RE: Data Responses, Informal Set 6
Cosumnes Power Plant (01-AFC-19)

**COSUMNES POWER PLANT
(01-AFC-19)**

**INFORMAL DATA RESPONSE,
SET 6**

Technical Area: Water and Soil Resources

FIGURE 1
 CONSUMNES POWER PLANT
CH2MHILL

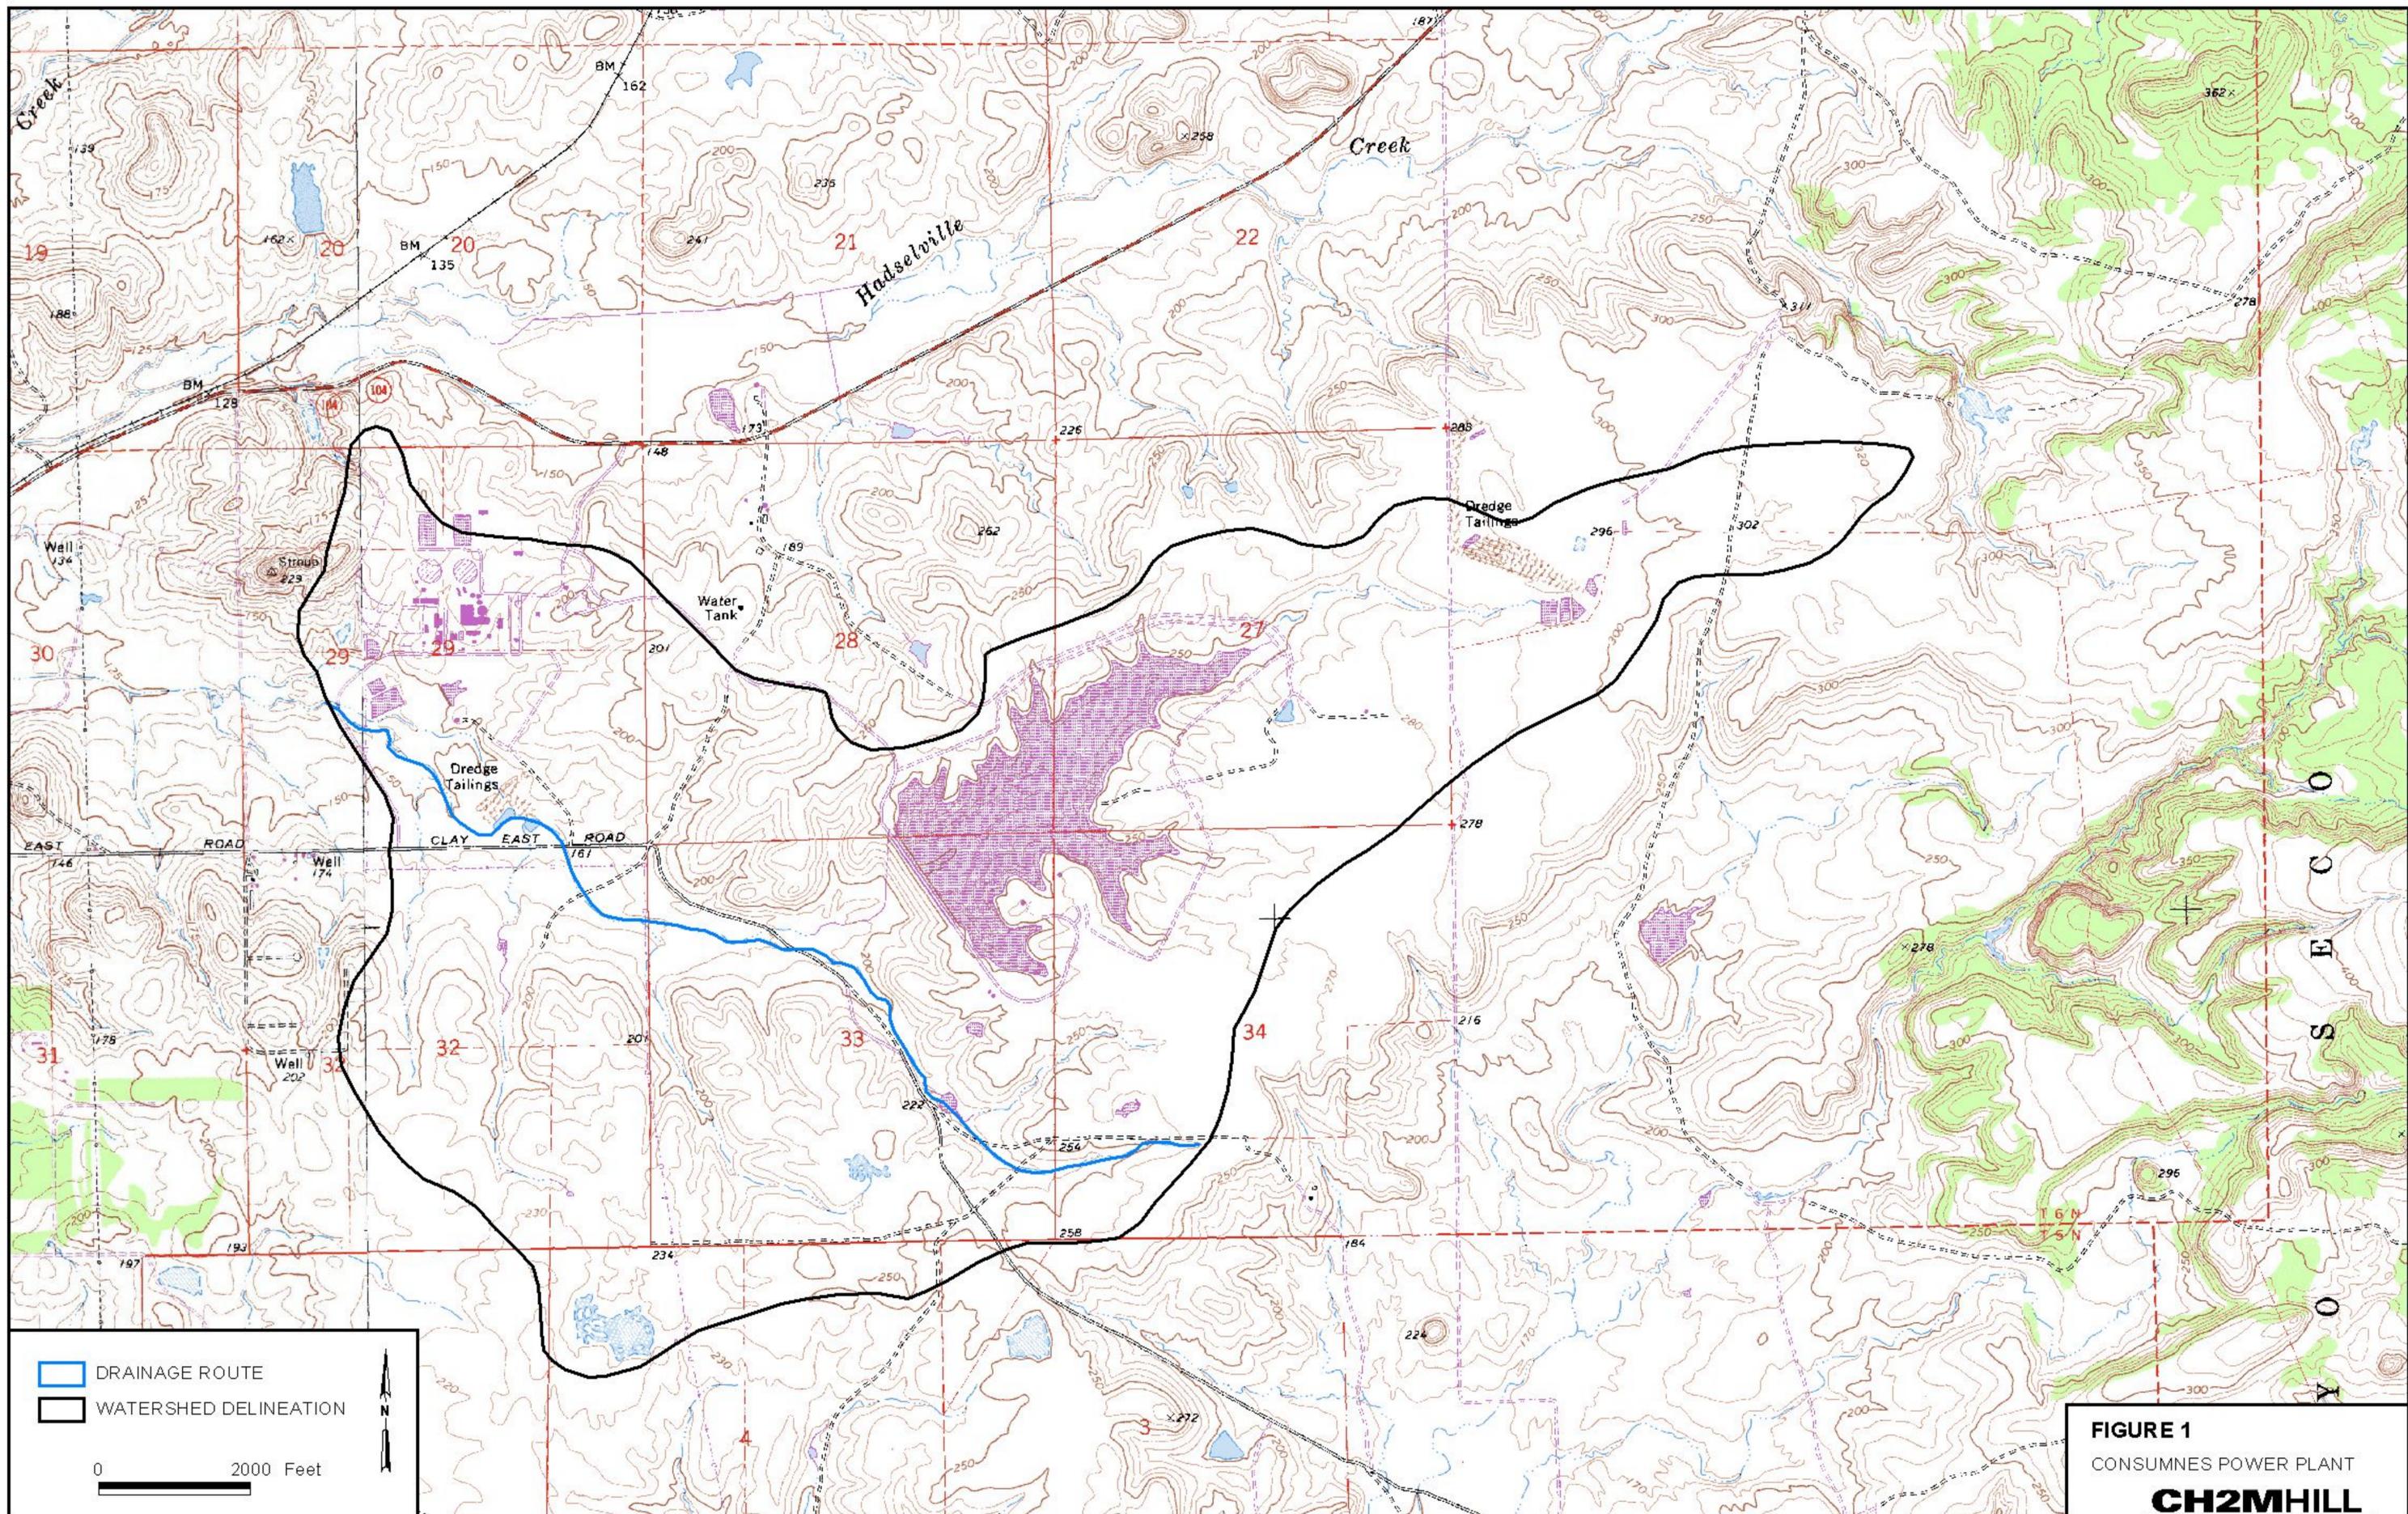
W&SR-4. Please provide HEC 1 hydraulic calculations to show how flow will be accommodated.

We estimated the 10-year and 100-year peak discharges for the four Clay Creek catchment scenarios using the rational method (as described in Dunne and Leopold, 1978). The Clay Creek drainage basin upstream of the project site and the "east" and "west" tributaries to Clay Creek (the drainages immediately east and west of the existing access road from Clay East Road to the proposed project site) were delineated on the United States Geological Survey (USGS) Goose Creek Quadrangle. Figure 1 is a map of the Clay Creek watershed and Figure 2 is a map of the "east" and "west" tributary watersheds. Both maps show the watershed boundaries and the principal flow path for each watershed. Each drainage area was measured using a planimeter. The catchment lengths were measured from the project site (for the entire Clay Creek watershed) and from each tributary's confluence with Clay Creek (for the tributaries) to the drainage divide following the principal channel. The relief of each catchment was determined by taking the difference between the elevation at the project site or confluence and the elevation at the drainage divide. A summary of the drainage area, catchment length, relief, and slope for the entire catchment and both tributaries is provided in Table 1. The average annual rainfall for the Rancho Seco Power Plant (RSP) was calculated as 16.72 inches by computing the mean of the total annual rainfall recorded by the East Bay Municipal Water District at Clay Ranch from 1931 through 1980.

As presented in Table 2, it is not anticipated that the construction of the proposed power plant would generate a significant increase in discharge. The results of this hydrologic analysis suggest that the rate of discharge would only increase 5 cfs, from 591 to 596 cfs, for the 10-year event and 5 cfs, from 1,213 to 1,218 cfs, for the 100-year event as a result of the proposed power plant construction.

Figure 1: Velocity distribution for cross section 2214 showing the CPP boundary as a blocked obstruction.

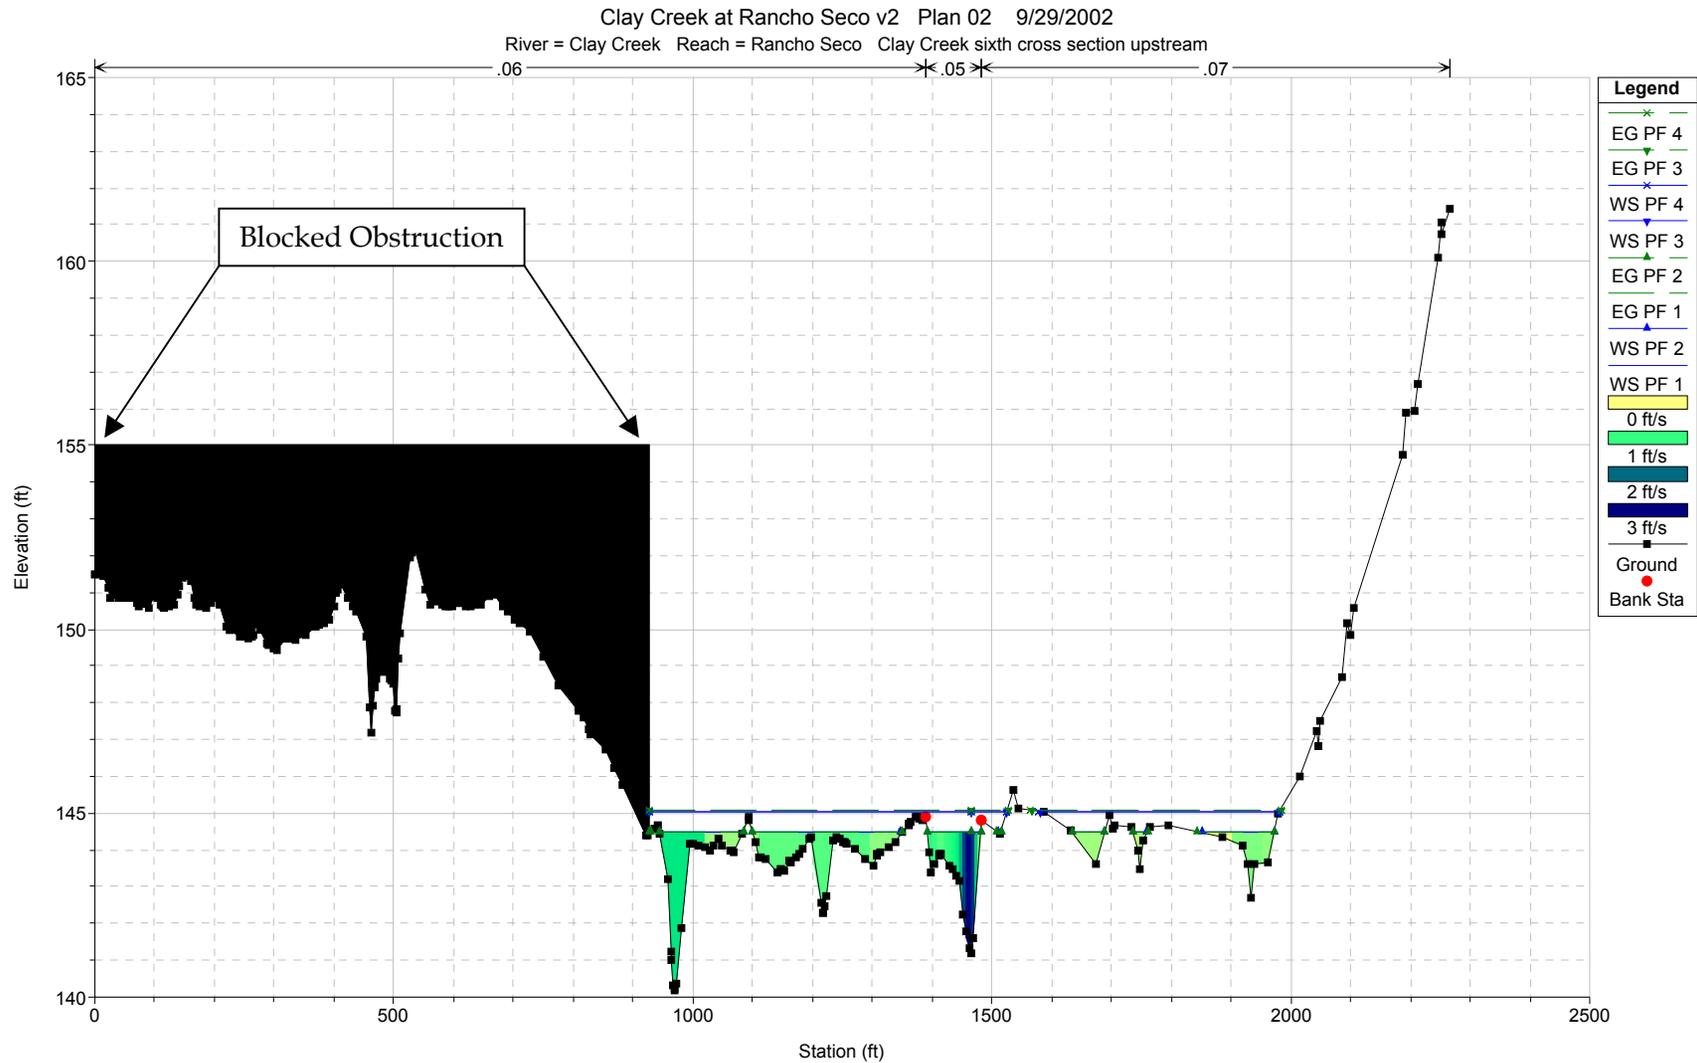
The California Energy Commission (CEC) requested estimates of the flow depths and velocities at the boundary of the CPP for the 10-year and 100-year peak discharges. The CEC also requested a comparison of project water surface elevations with and without encroachment by the CPP. This document describes the analyses used to generate those estimates and summarizes the results of each analysis.

First, the CPP site boundaries were entered as “blocked obstructions” in the appropriate cross sections of the HEC-RAS model for the CPP site. Next, the HEC-RAS flow distribution capability was used to determine flow depths and velocities adjacent to the blocked obstructions (i.e. at the site boundaries). The flow distribution routine in HEC-RAS divides flow through a cross section into a specified number of cells and then applies Manning’s equation using local hydraulic geometry to determine the flow depth and average velocity through each cell. Figure 1 is an example velocity distribution for cross section 2214 (note the blocked obstruction from Station 0 to Station 928). Depths and velocities predicted at the CPP boundary for the 10-year and 100-year discharge are summarized in Table 1 and Table 2, respectively.
